**OCHC 214 Somerset**

Design Brief

214 Somerset St. E., Ottawa, ON, K1N 6V4  
*CSV project # 2022-2471*

Figure 7: Level 01 Floor Plan

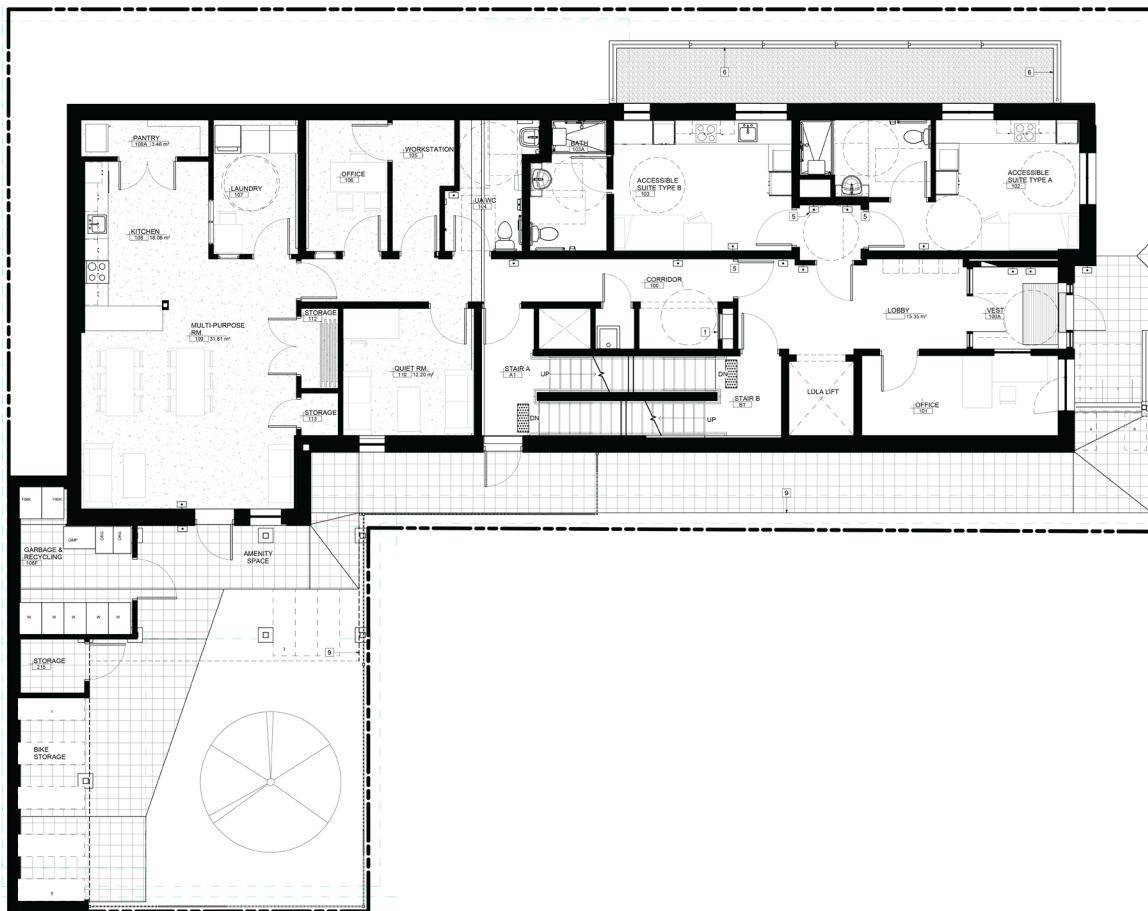
*2. City Staff wanted to ensure that waste management was considered. They requested details of the garbage storage area as well as the path and staging area for the containers.*

*4. Ensure there is sufficient bike parking for the development*

Response: The garbage bins will be stored in the accessory structure located in the rear yard. This structure is located in the rear yard. It provides space for the following:

Response: 20 bicycle parking spaces are planned including 12 covered, 3 at the Somerset street entrance, and 5 at the Nelson street entrance.
